CITY PROJECT NO. 14079
CONTRACT NO. 8709

ADDENDUM #1- 5/17/2024
REVISED THE
FOLLOWING:
TITLE SHEET
GI2-GI5, PD1-PD2, PD5-
PD6, P1-P2, P5-P6, U2-U6
REMOVED THE
FOLLOWING:
GI2 AND GI6

REVISION #1- 8/15/2024
REVISED THE
FOLLOWING:
EC4, EC6, GI1, GI3-GI5,
PD2-PD6, P2-P6, U4-U5,
W1, X4-X5, X7, X9, X12

REVISION 2: 3/21/25
REVISED THE
FOLLOWING:
P2, P3, PD2, PD3, U1, U2,
U3, U7

GI-4

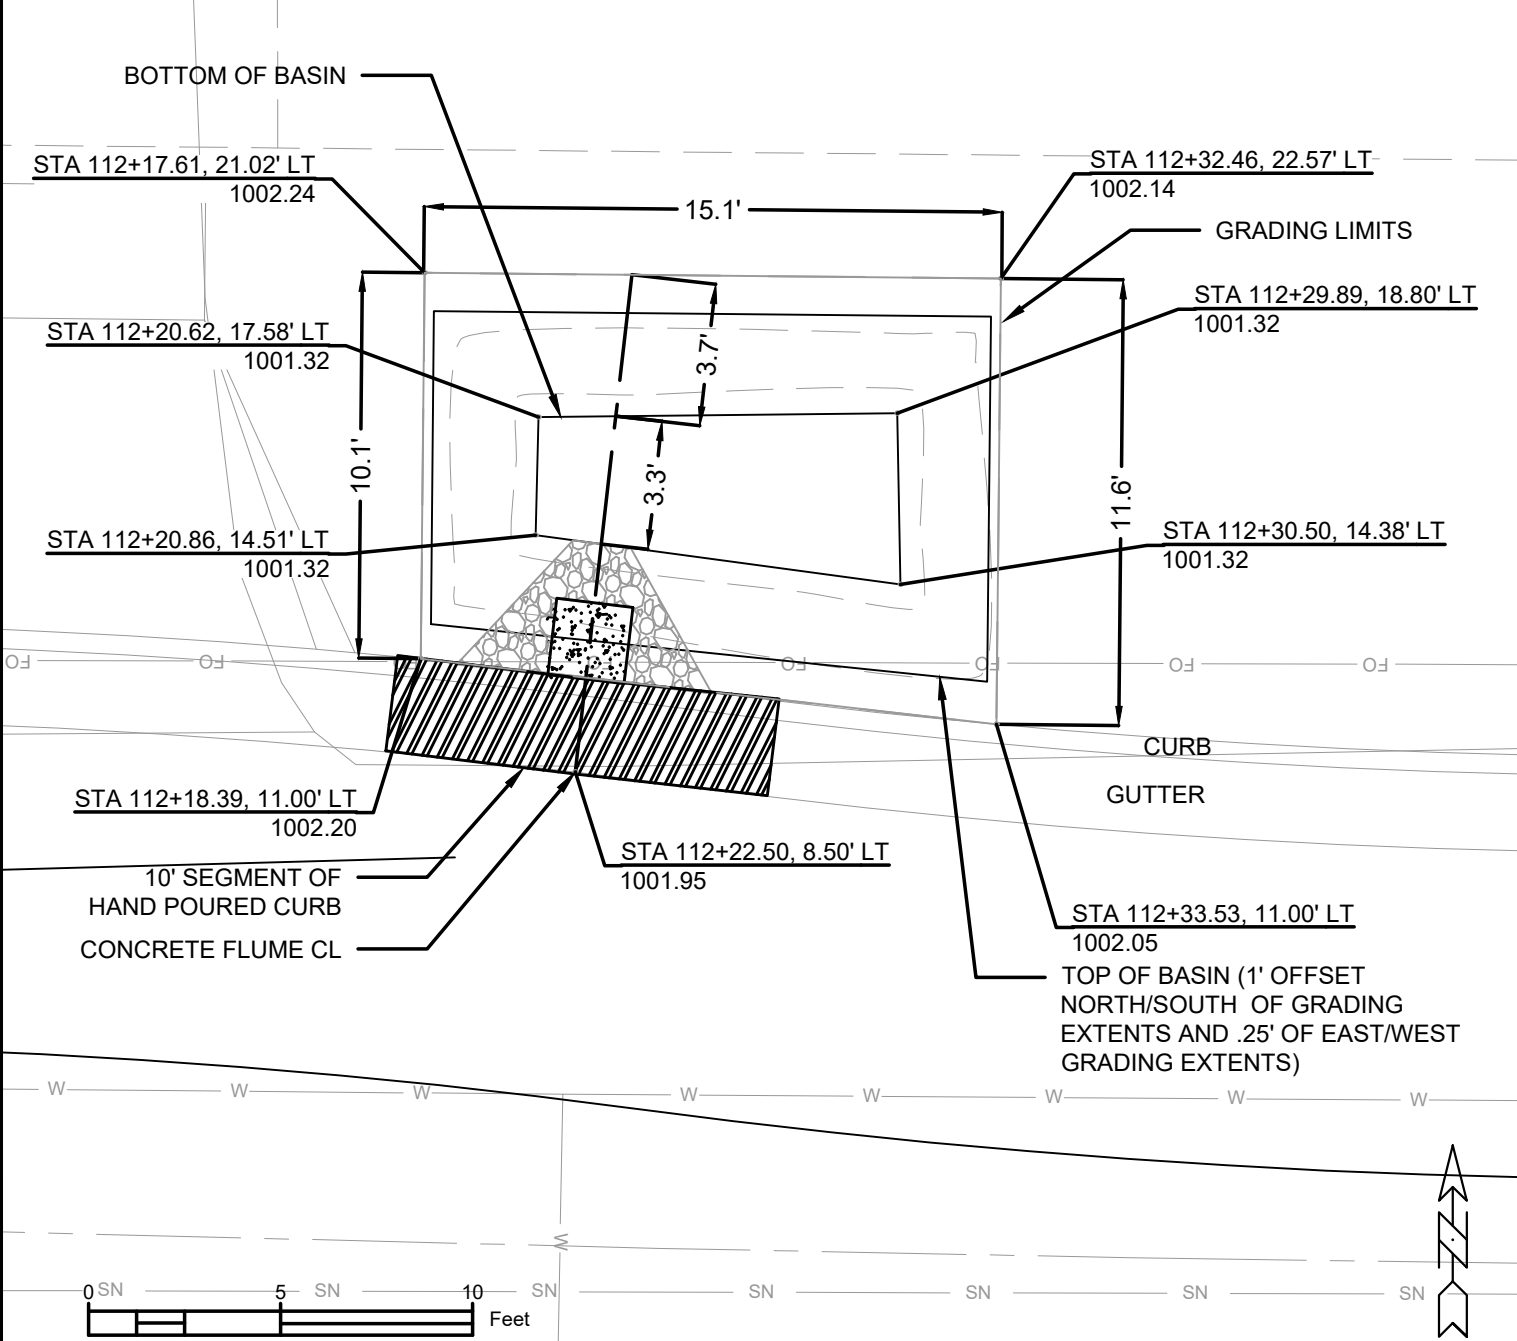
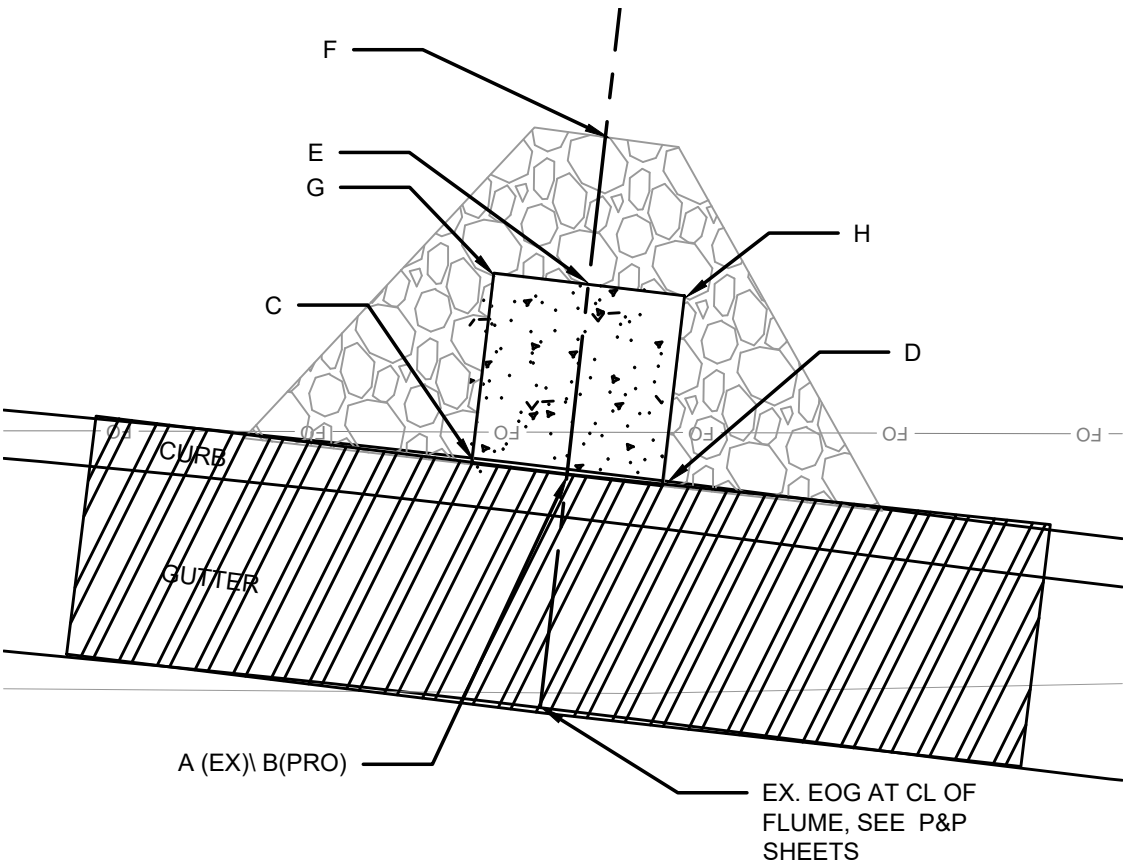
REVISION 1:
UPDATED TO
NEAREST ALIGNMENT

GI-5

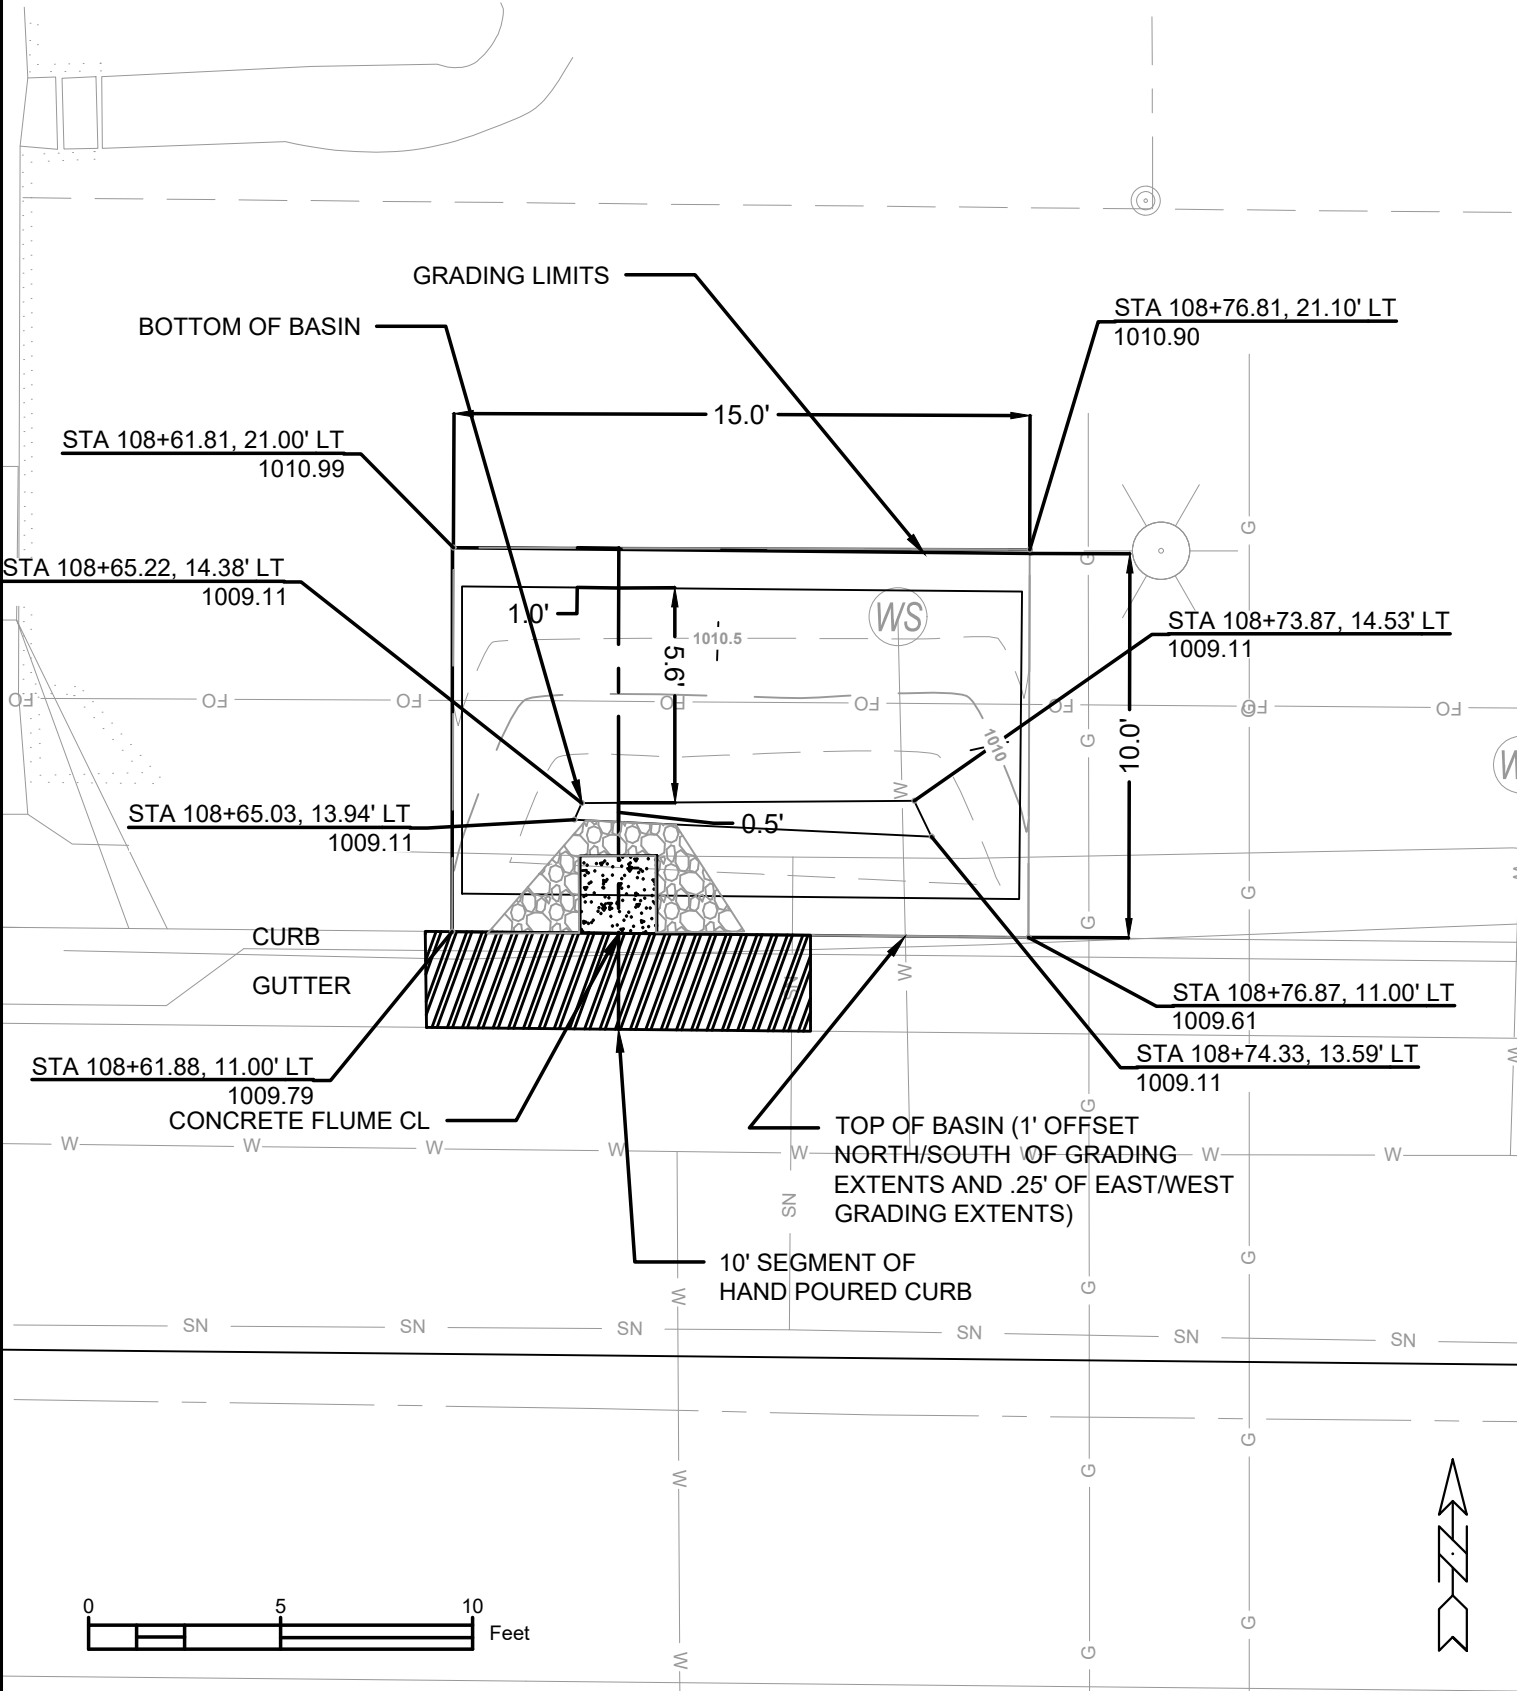
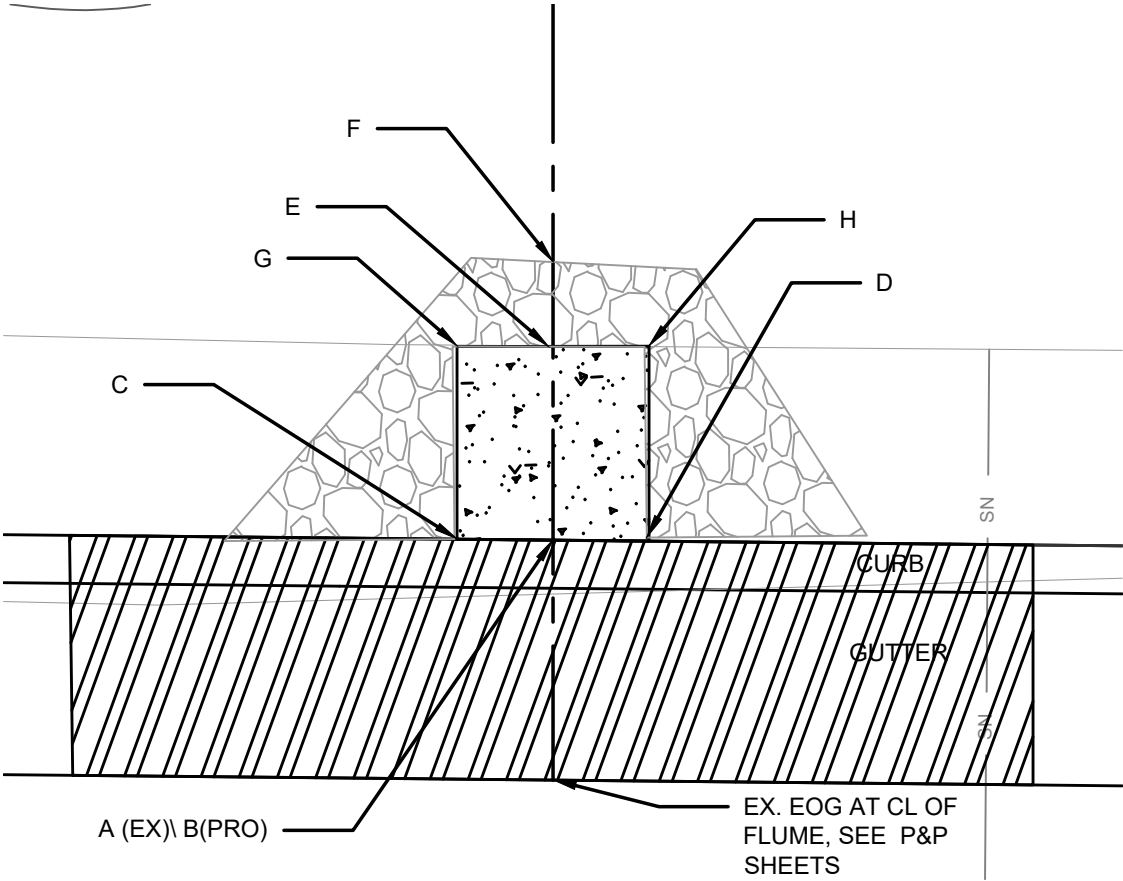
REVISION 1:
UPDATED TO
NEAREST ALIGNMENT

PLAN DETAILS BEVERLY ROAD		14079
DONCASTER BEVERLY DANBURY RECONSTRUCTION		MADISON, WI
M:\DESIGN\Projects\14079\CAD\Streets\14079EN-PnP.dwg		CONTRACT NO: 8709
		14079
14079		PD-1

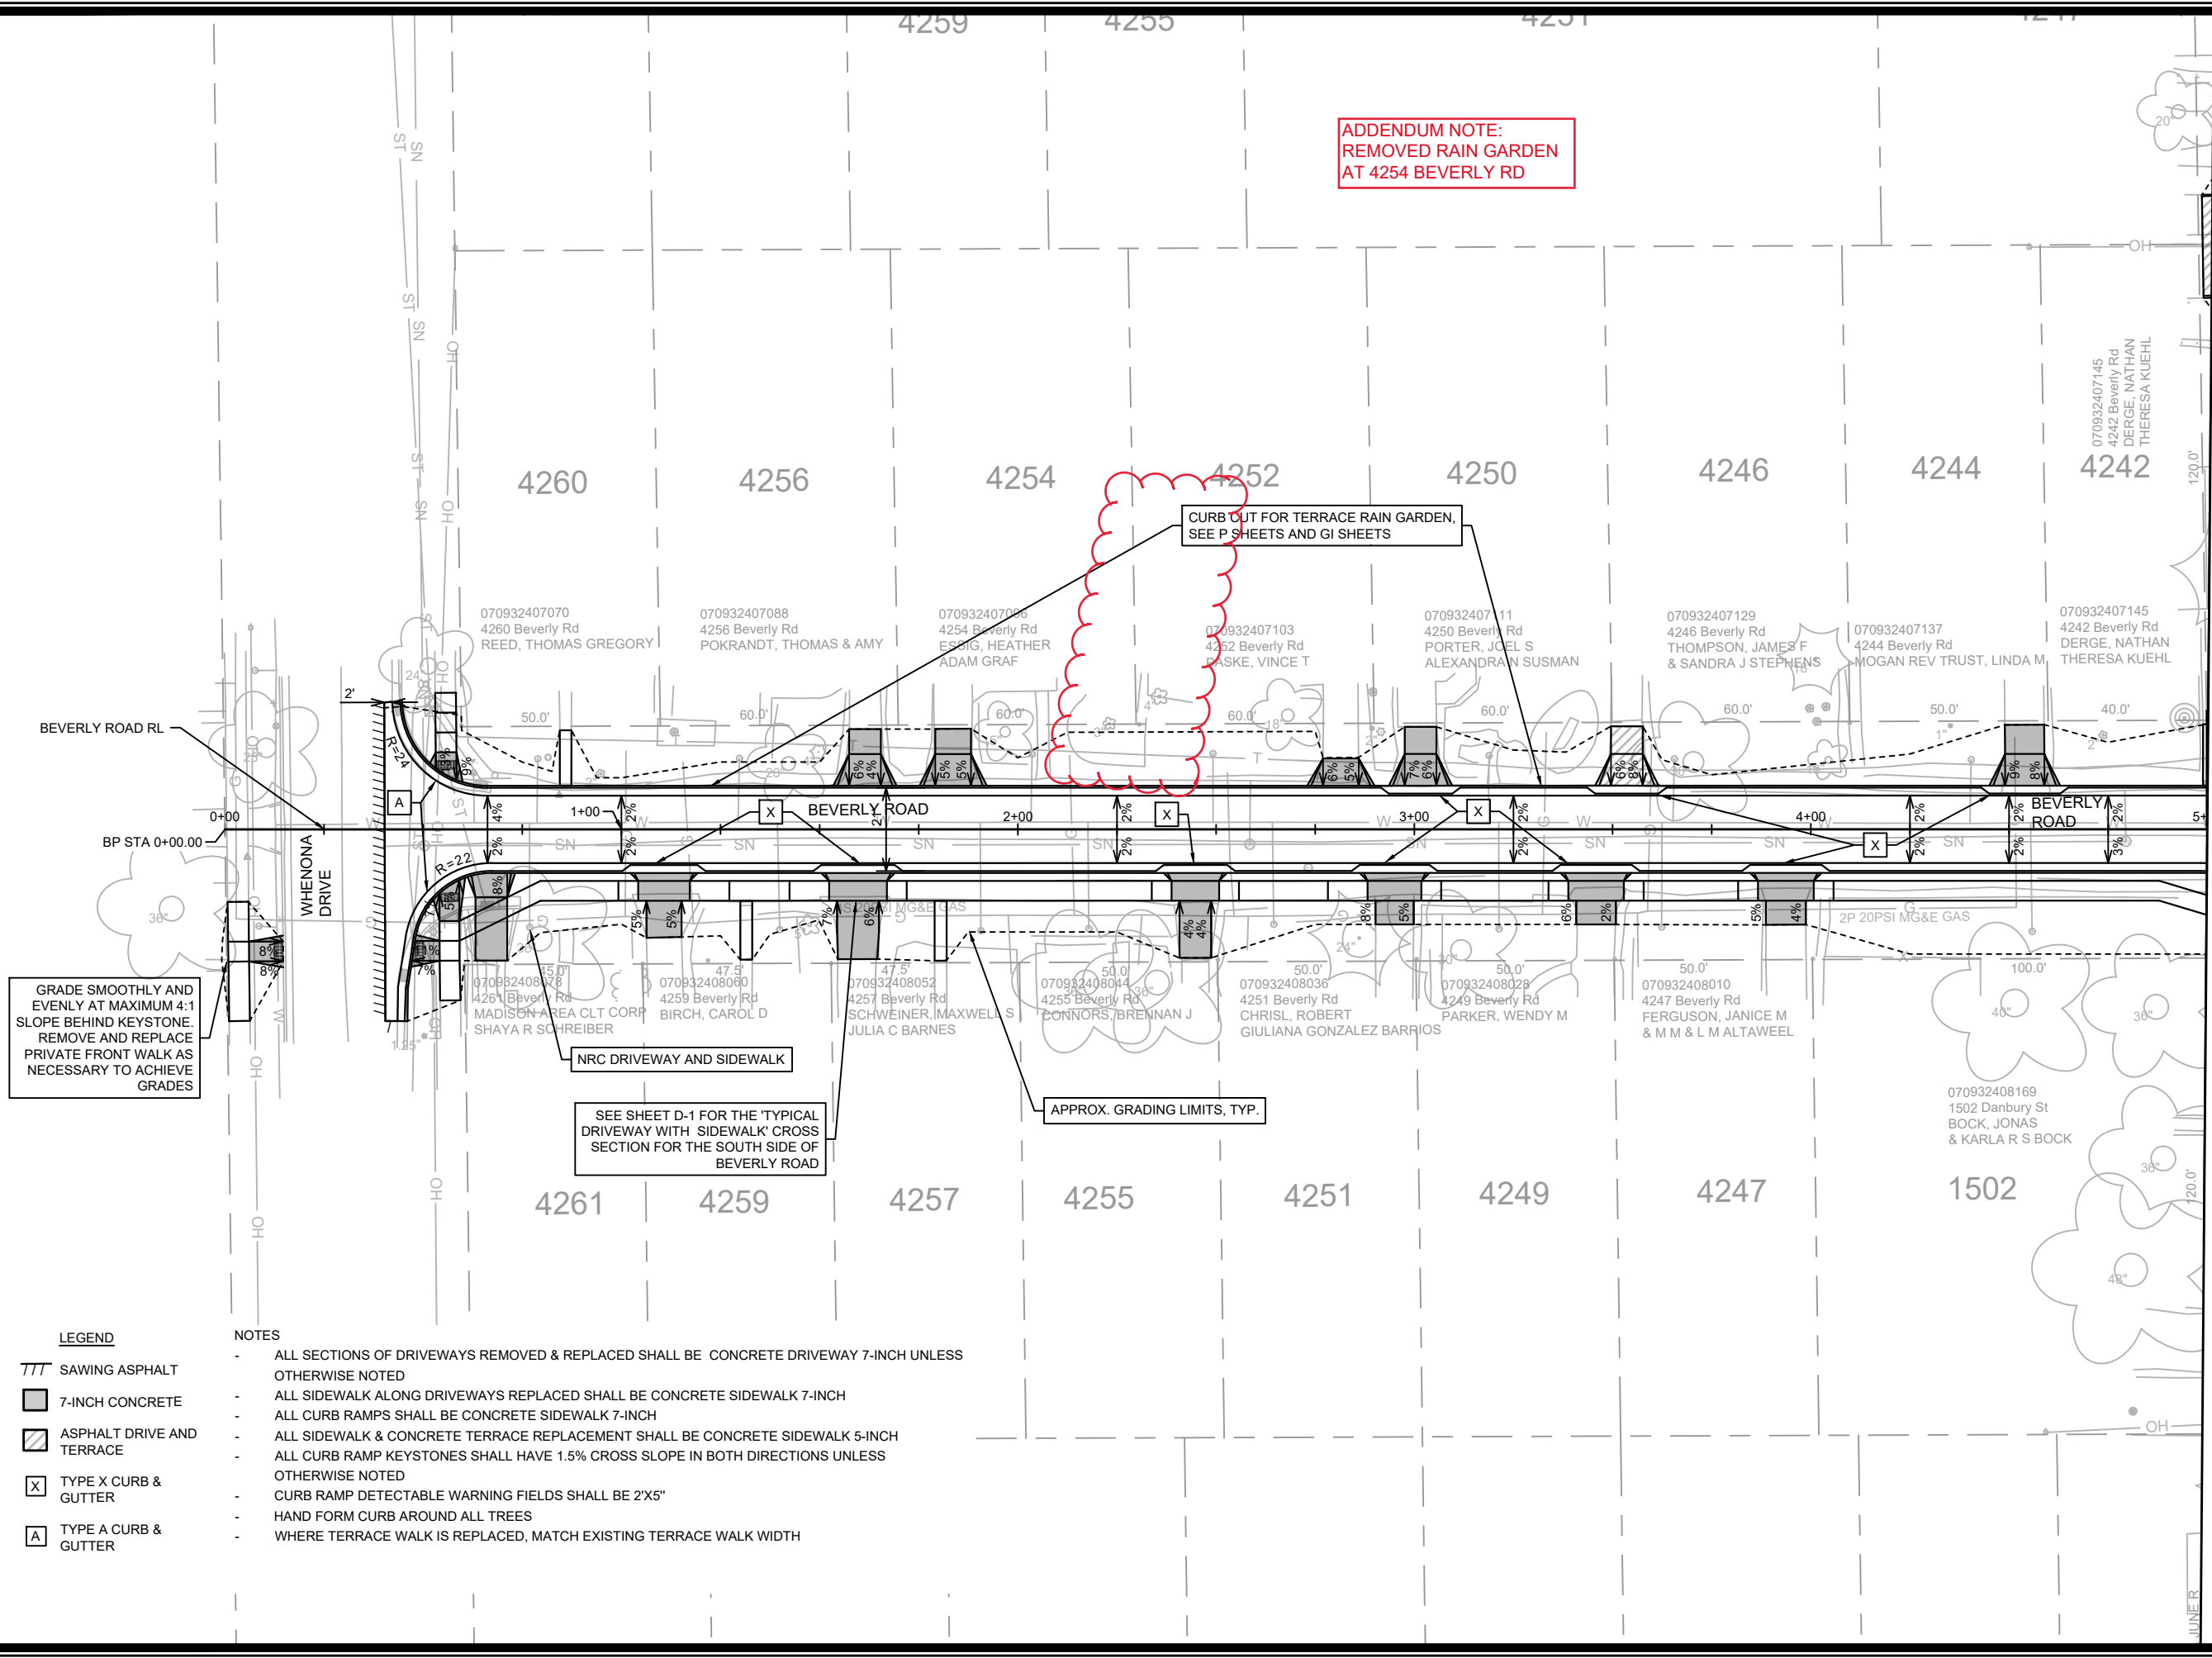
ADDENDUM NOTE:
REMOVED RAIN GARDEN
AT 4254 BEVERLY RD
